ECONOMIC COMMISSION FOR EUROPE

Working Party on the Construction of Vehicles

REVISED PROPOSAL FOR DRAFT 04 SERIES OF AMENDMENTS TO
REGULATION No.44
(CHILD RESTRAINT SYSTEMS)

Transmitted by the French Delegation

Fig 0a

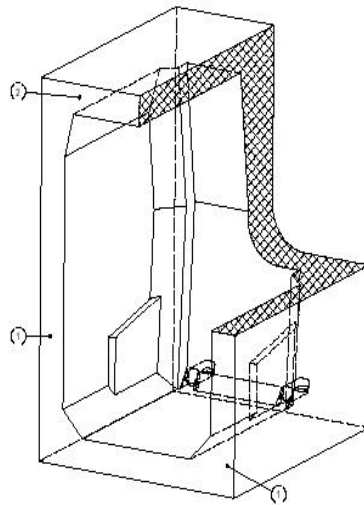
“2.31. **Vehicle seat fixture (VSF)** means *a fixture, complying to dimensions shown in figures 0a and 0b, used by a child restraint manufacturer to determine the appropriate dimensions of an ISOFIX child restraint system and the location of its ISOFIX attachments .*”

Figure 0d Dimensions in mm

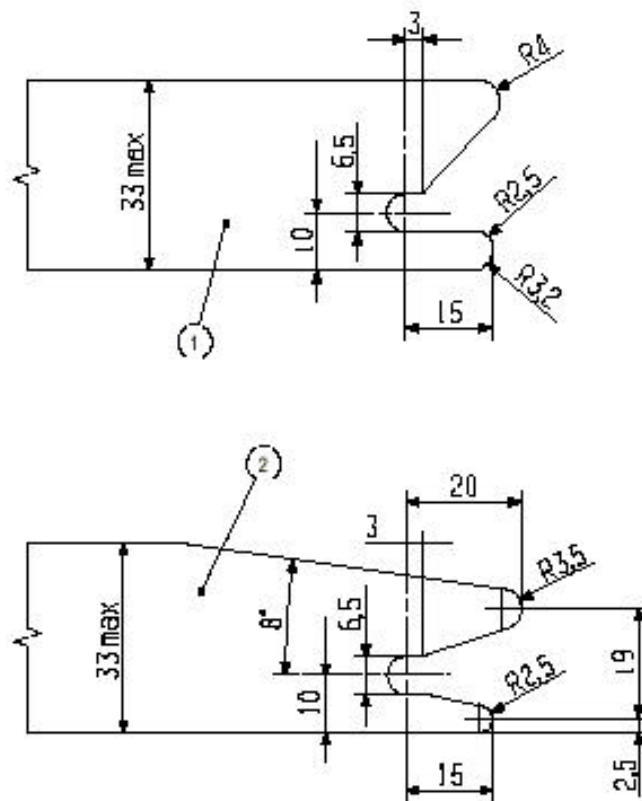
Dimensions for the portion of the child restraint system connector that engages the anchorage bar must not exceed the maximum dimensions given by the envelope in Figure 0d

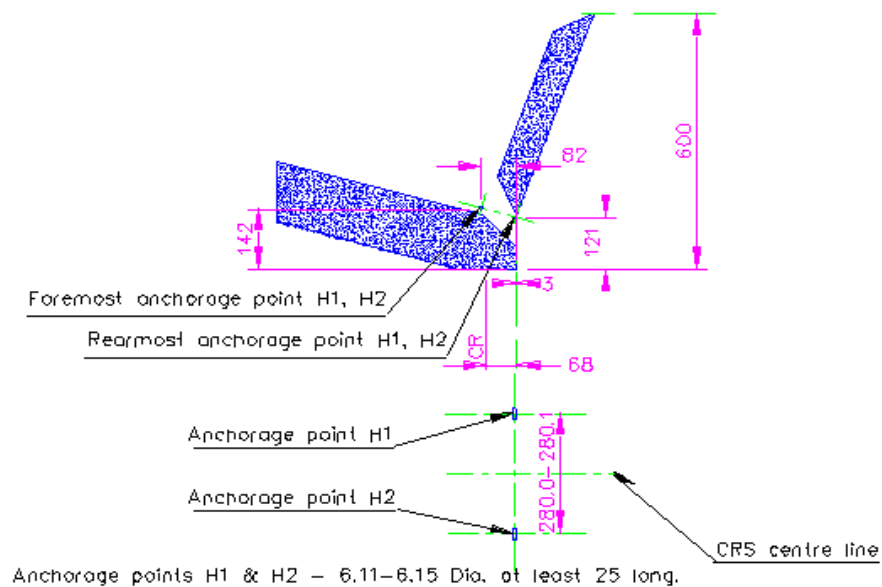
" 2.3. For child restraints using ISOFIX attachment, points H₁ and H₂.

" 3. Anchorages A, B **and/or H₁ H₂** and D shall be used (... no change....) upper anchorage.

4. Anchorages A, B **and/or H₁ H₂**, E and F shall be used (... no change....) upper anchorages."

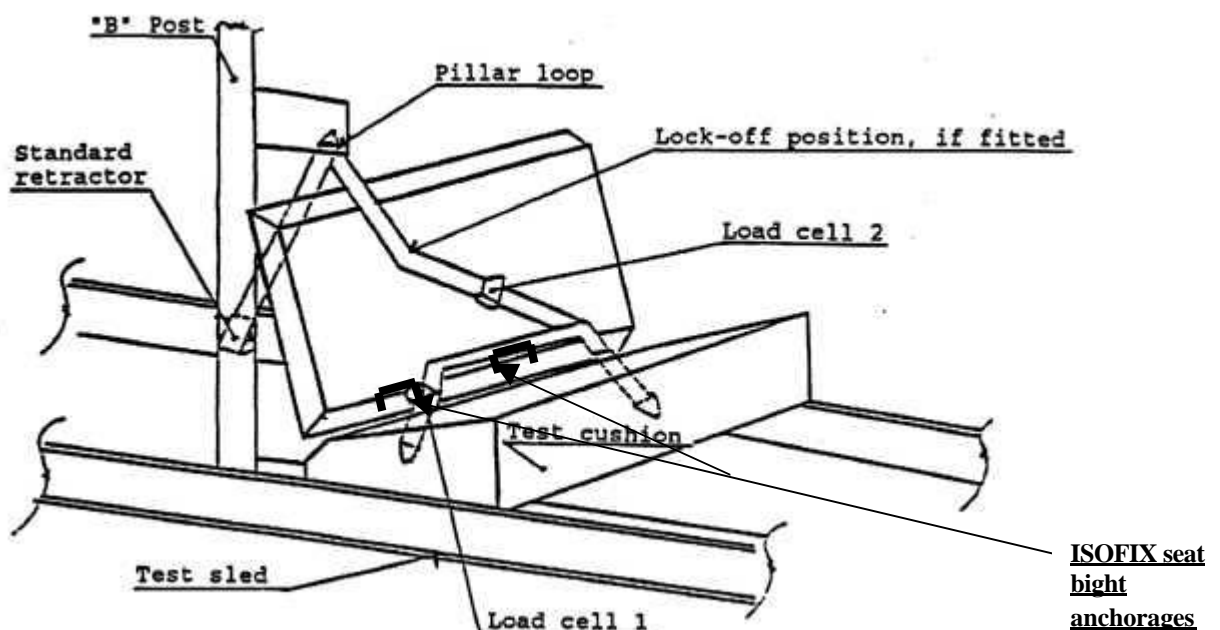
- Amend paragraph 8 to read :
For testing of child restraints in the "universal" and "restricted" categories, a standard retractor belt, as specified in annex 13, **and/or an ISOFIX anchorage**, shall be fitted to the test seat."
- Insert a third figure to see :
